CITY OF NEWTON, MASSACHUSETTS

ADDENDUM #1

INVITATION FOR BID #13-20

WASHINGTON STREET PLANTINGS

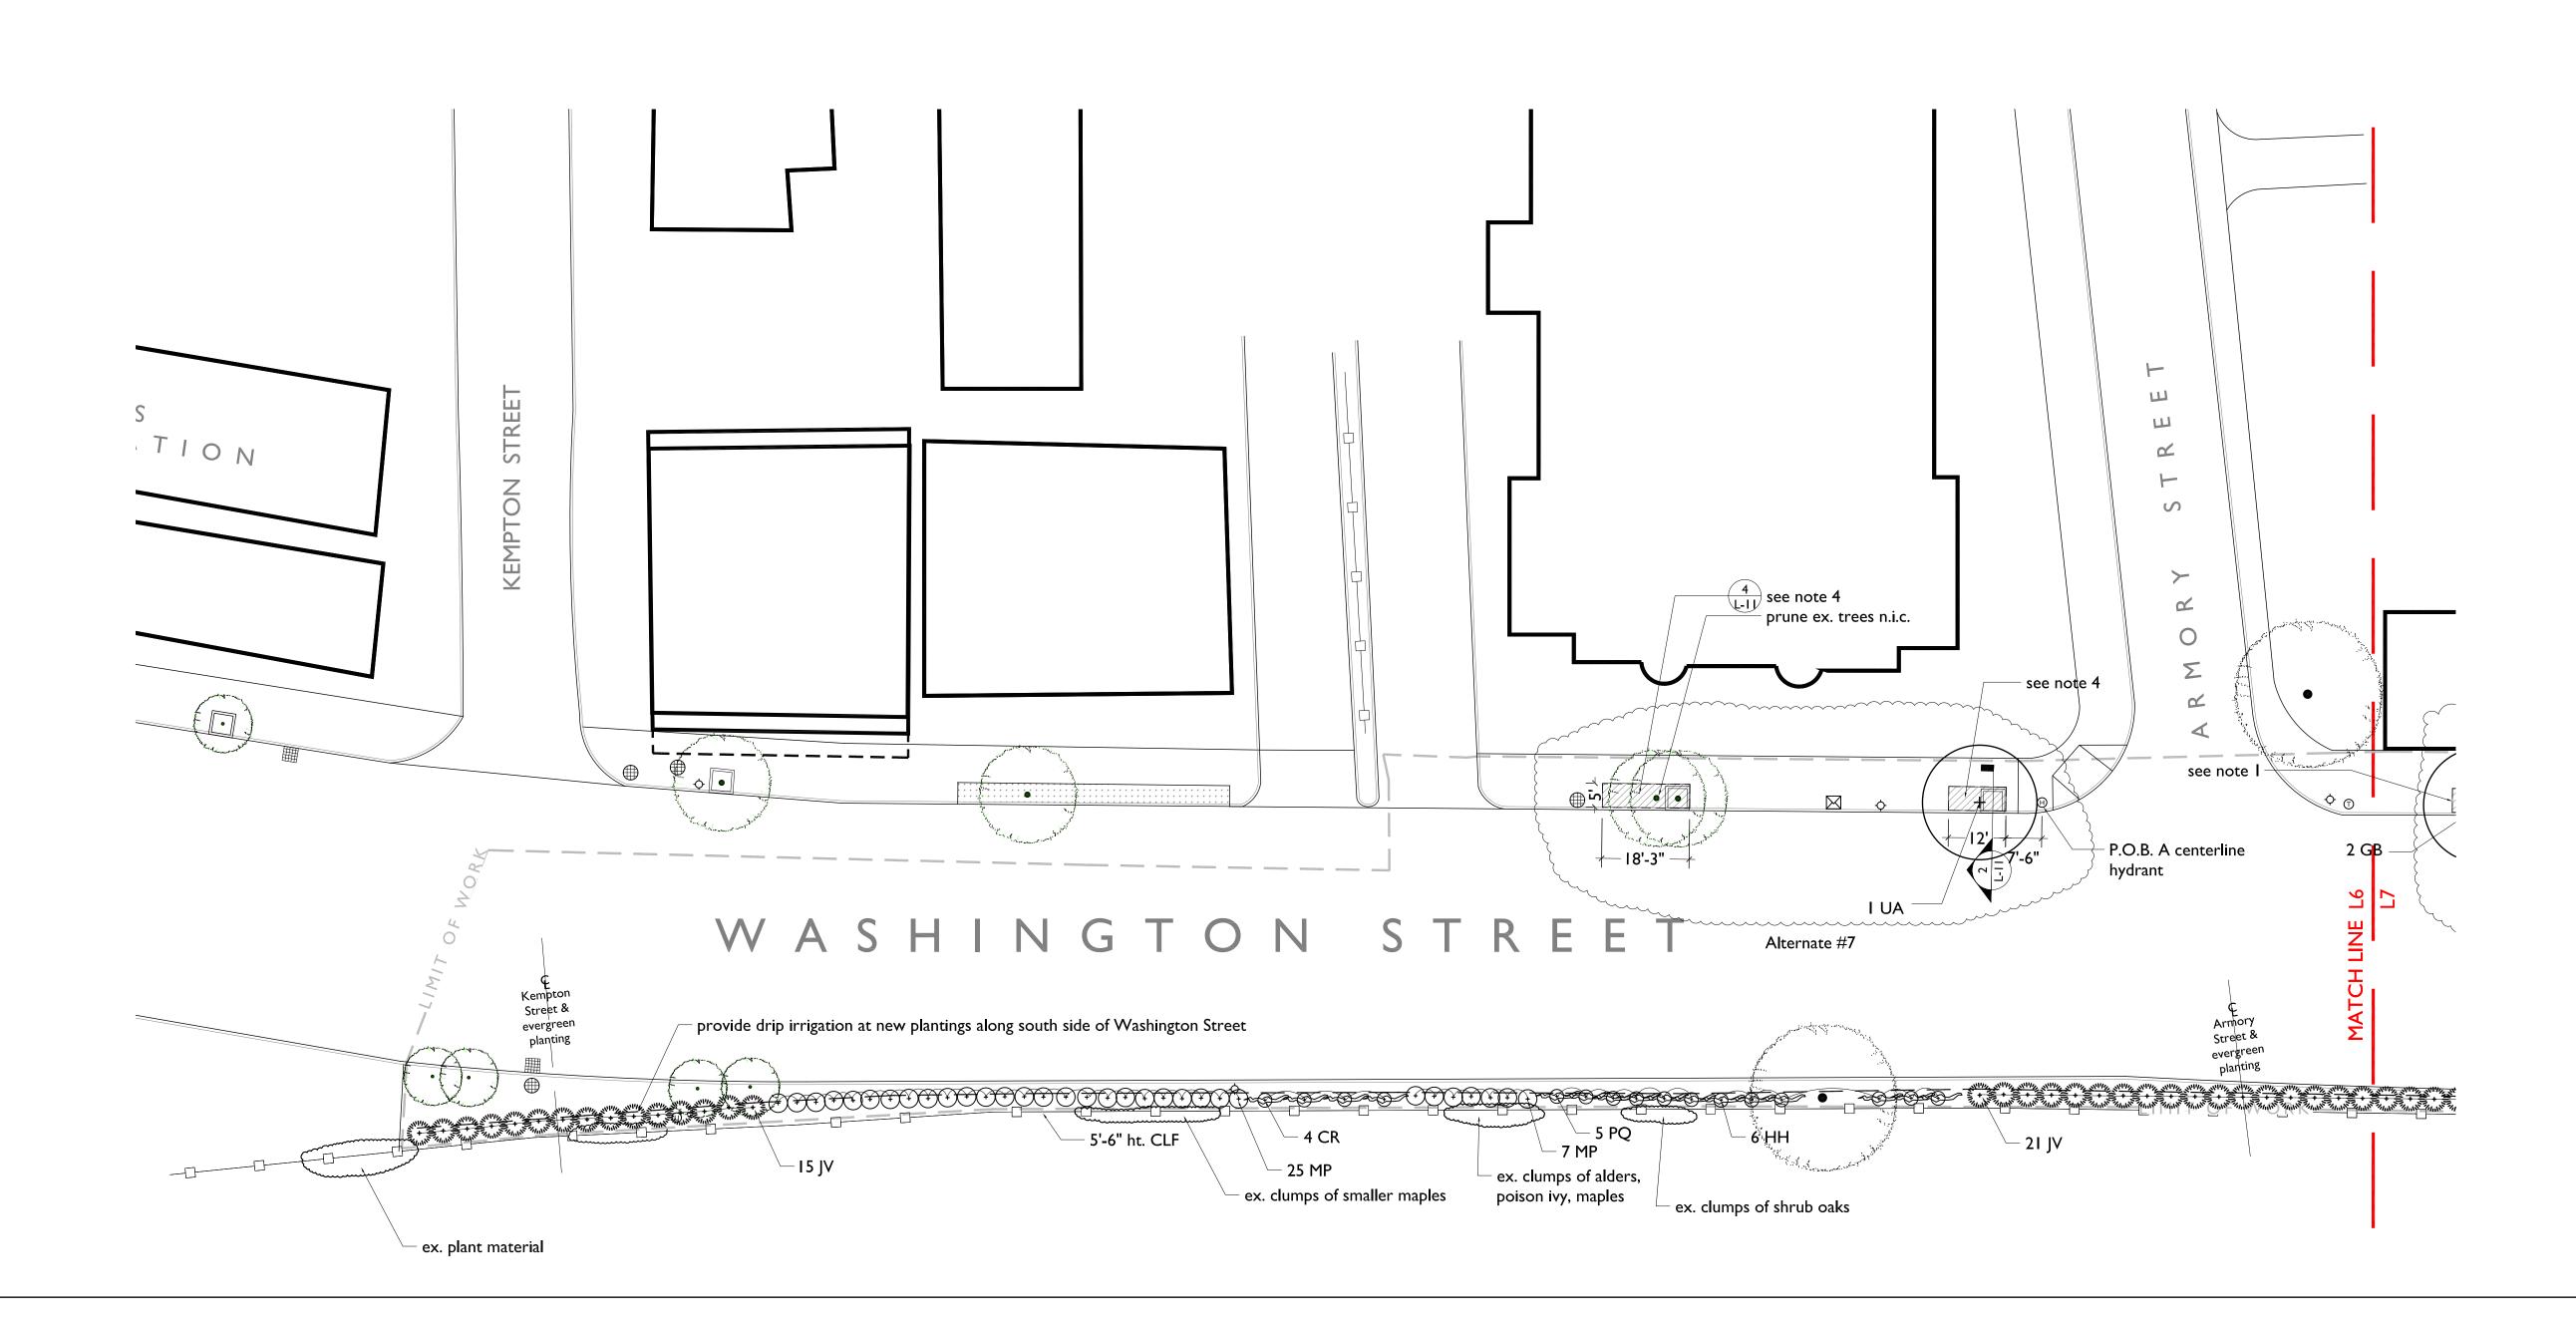
- 4. The bid Alternates will be changed as shown on the revised plan and bid sheets.
- 5. The issue of the one year guarantee was discussed at length. Since the temporary irrigation system is deleted from the scope of work, the Contractor shall ensure that all the plantings have adequate moisture during the growing season of 2013 such that they are in a healthy condition until inspection during the first week of October 2013 (as scheduled). We note that the contractor is not responsible for maintenance of the plantings during the guarantee period. There is not requirement for the contractor to weed, re-mulch, prune or spray for insects or other diseases after the date of "certification of acceptance" which would be issued for the completion of the work.
